Project: The Landings, Land at Ford Airfield

Report Ref: 2205773-R06A

Environmental Health Officers at ADC have provided comments relating to the Noise Assessment² (the NIA) which was submitted as part of the application. This Technical Note accompanies the NIA and provides responses to the EHO comments.

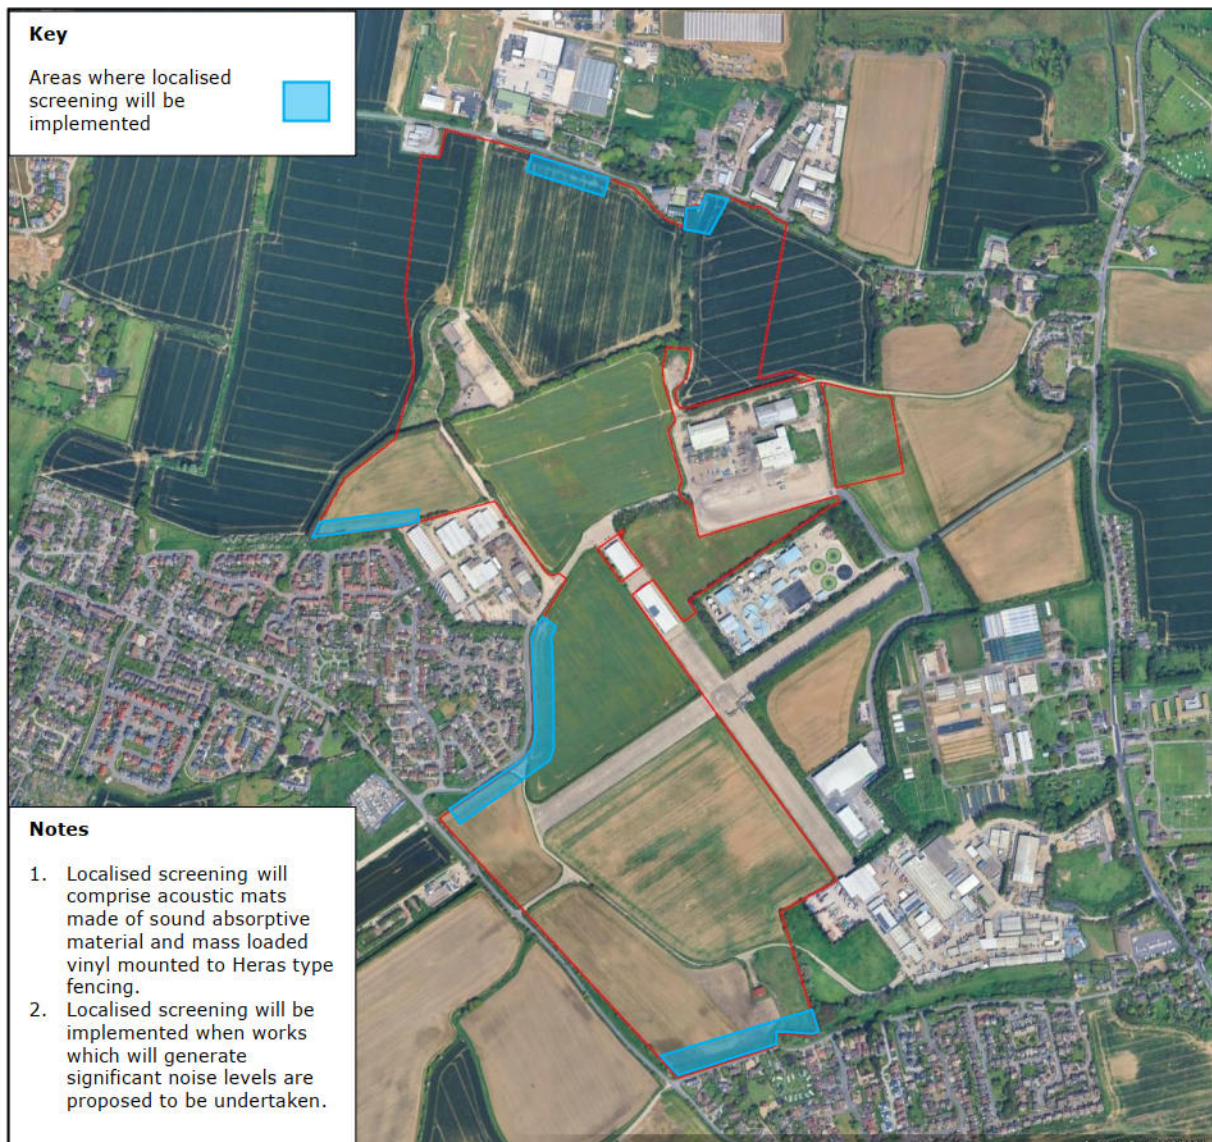
2. A 10dB reduction from a noise barrier would be applied in optimal conditions. The information provided by the applicant indicates that optimal conditions may not be reached in this case because:
 - a) Paragraph 5.8 indicates that the barrier will have a minimum surface mass density of 10kg/m², however, standard acoustic barriers have a surface mass density of 20kg/m².

As an additional preventative measure, localised screening will be installed where works which will generate significant noise levels, such as heavy machinery operations or the use of hand tools, such as angle grinders or jackhammers, are proposed within 45m of dwellings. The localised screening will comprise acoustic mats made of sound absorptive material and mass loaded vinyl mounted to Heras type fencing.

These fences are mobile and will be positioned as close as possible to areas of works to provide the highest reduction in noise levels, expected to be within 5-10m from the works. This removes the need to identify and react to potential exceedances. A markup of the areas where localised screening will be implemented is shown overleaf.

The localised screening only needs to reduce noise levels by a maximum of 3dB, based on the predicted noise levels. Through a combination of acoustic absorption and additional screening the localised screening is expected to comfortably provide this additional reduction and therefore noise levels will not exceed the target noise level.
